RESEARCH REACTOR CENTER

August 24, 2011

SUBJECT: Written communication as specified by 10 CFR 50.4 regarding an application to amend Amended Facility License R-103 by revising the University of Missouri-Columbia Research Reactor Technical Specification 2.1, "Reactor Core Safety Limit," pursuant to 10 CFR 50.90

TECHNICAL SPECIFICATION

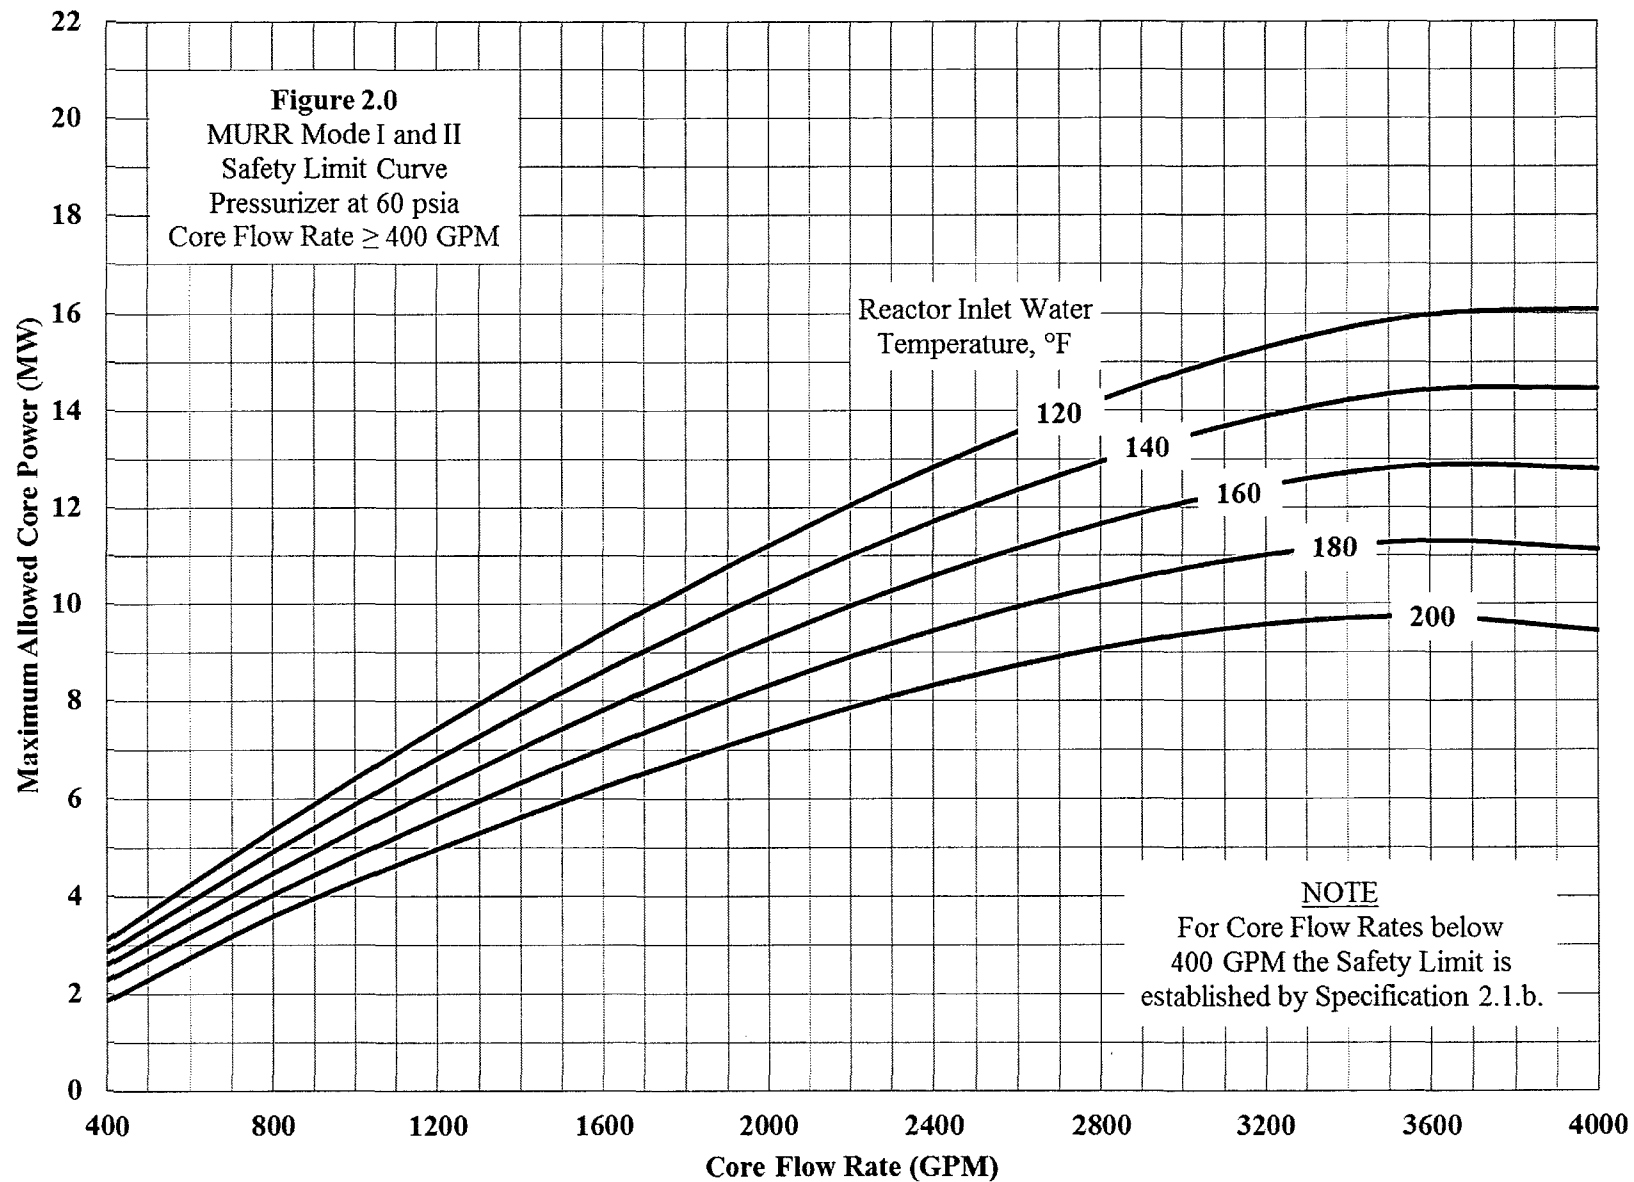
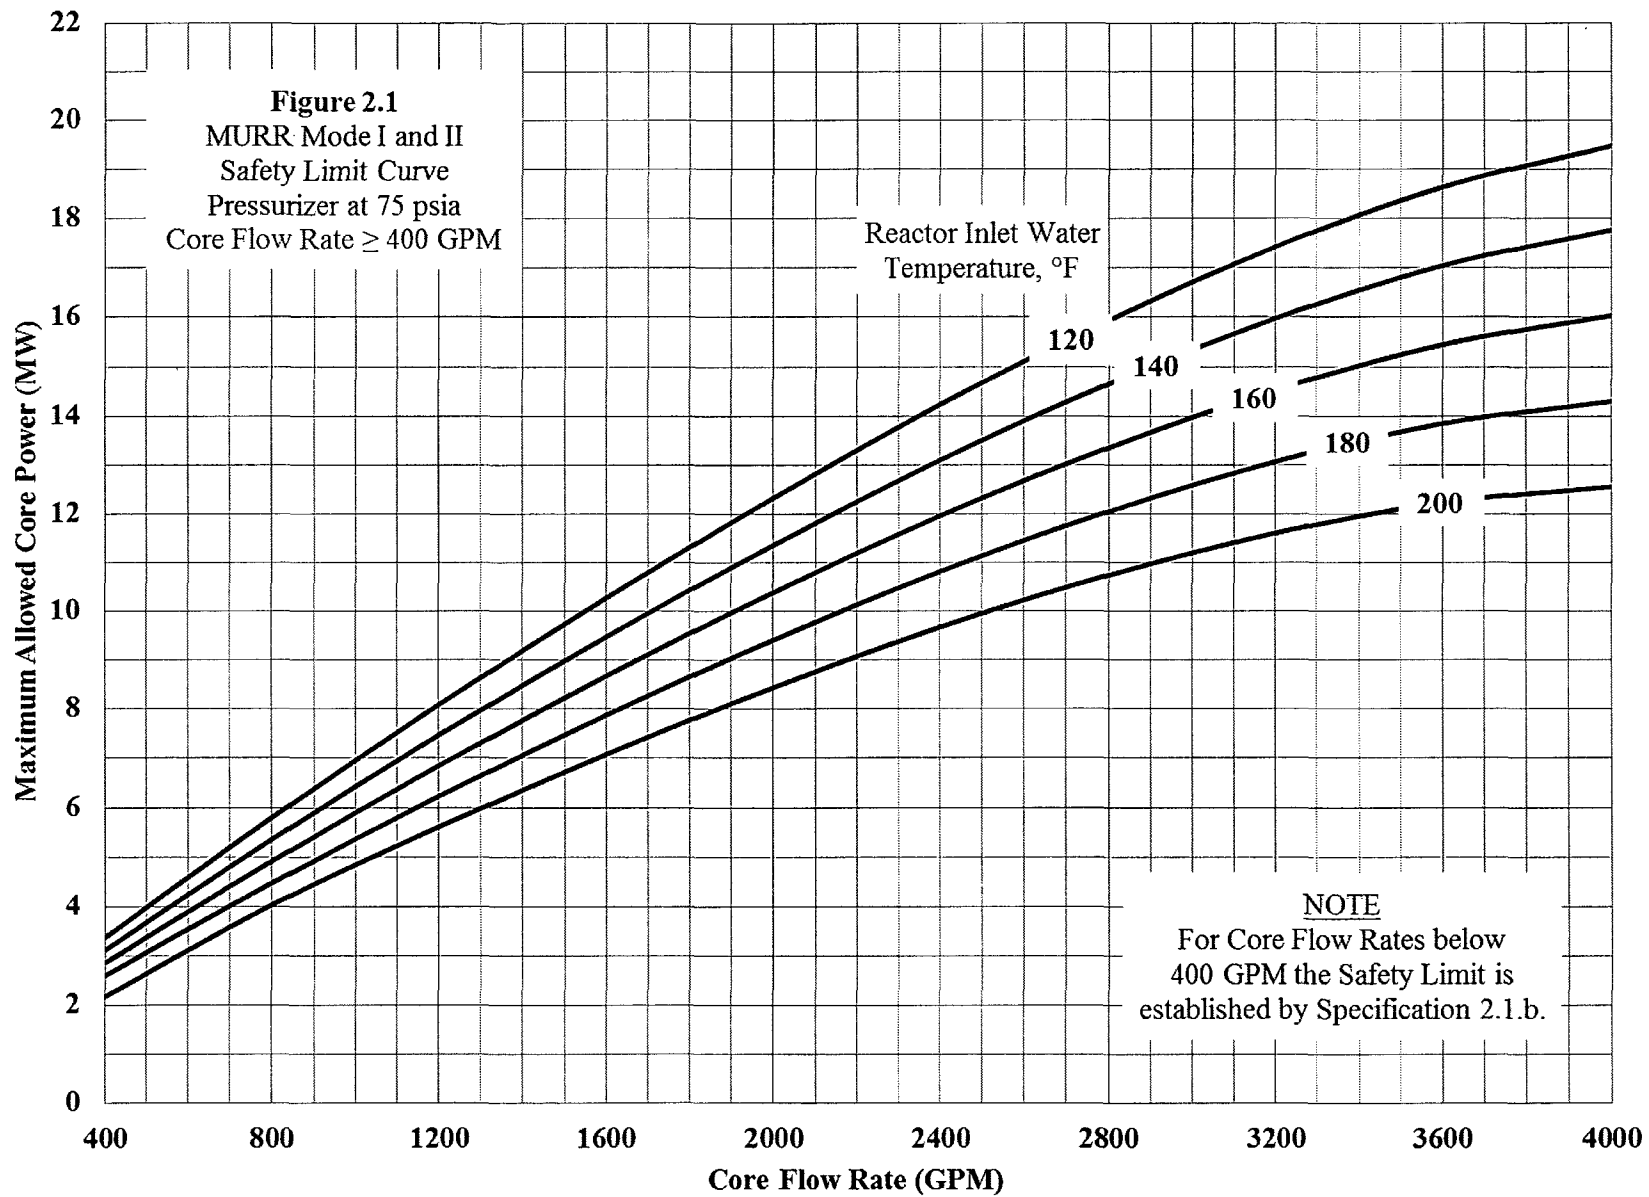
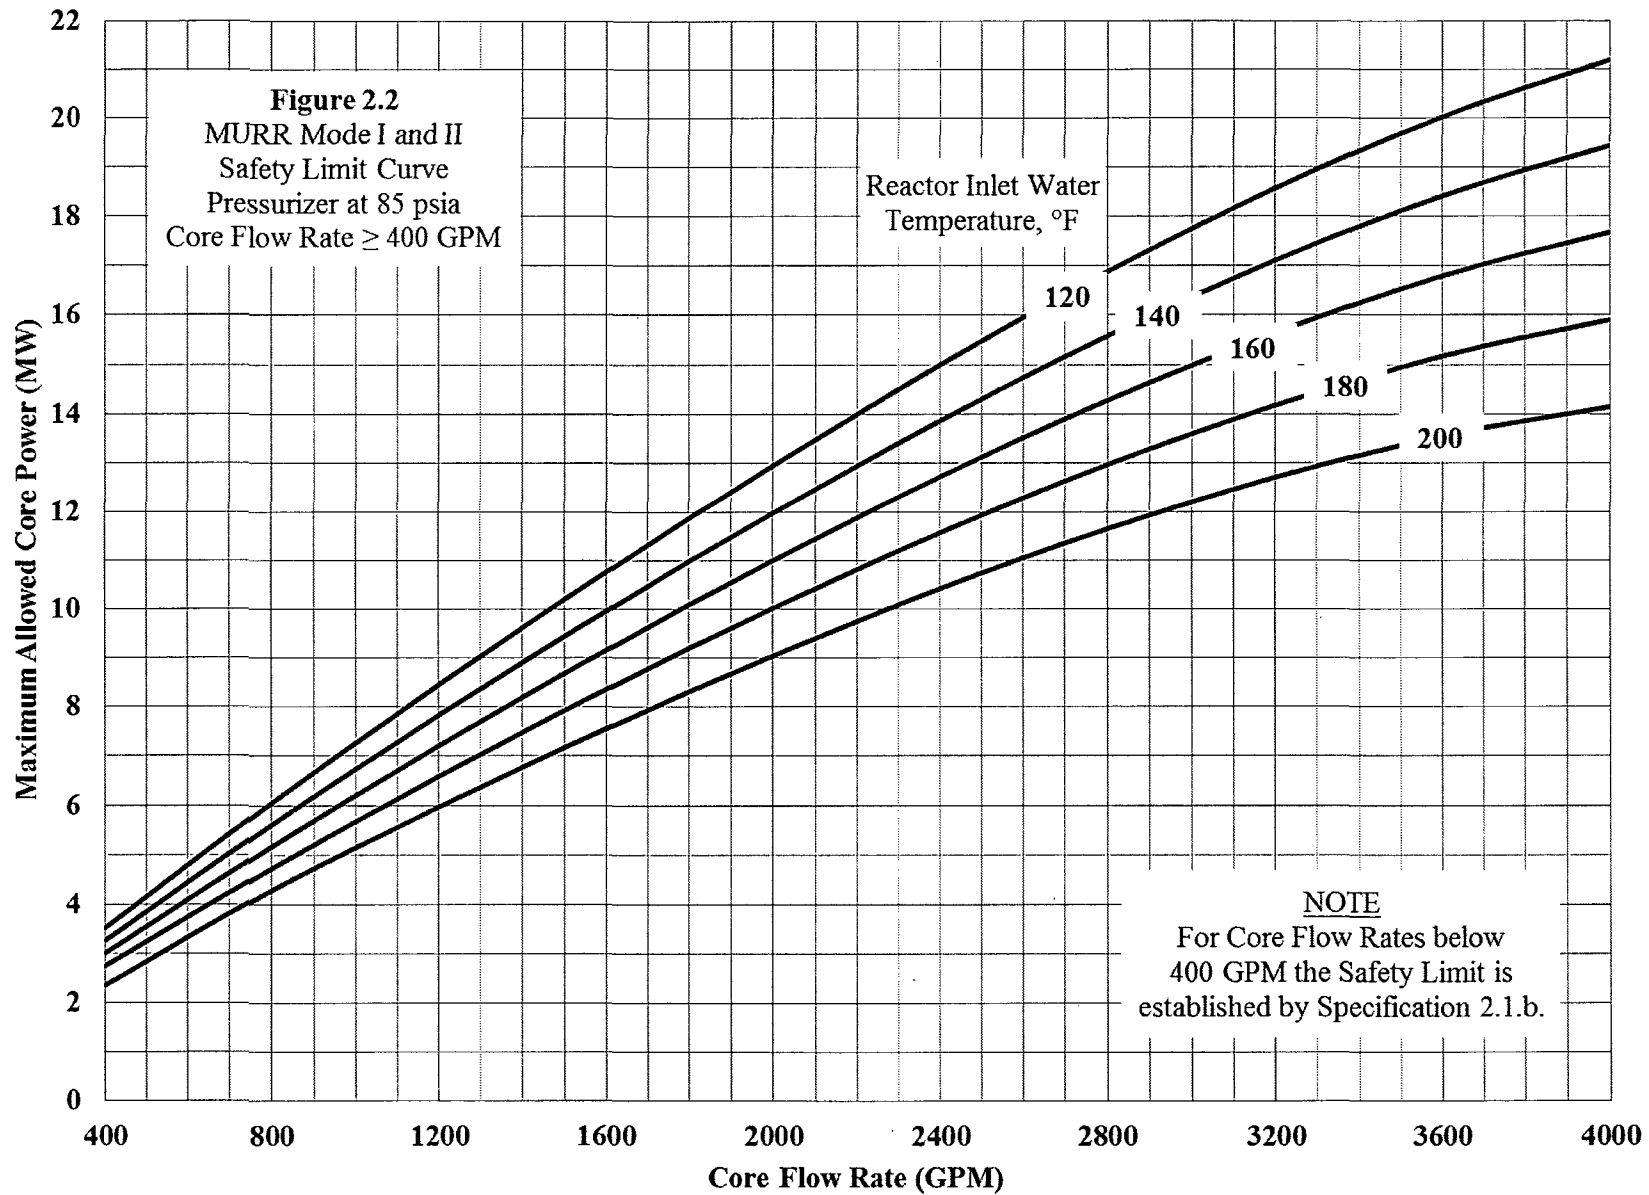
Reactor power, coolant system flow, temperature and pressure shall not exceed the following limits during reactor operation.

a. Mode I and II (Core Flow Rates ≥ 400 gpm)
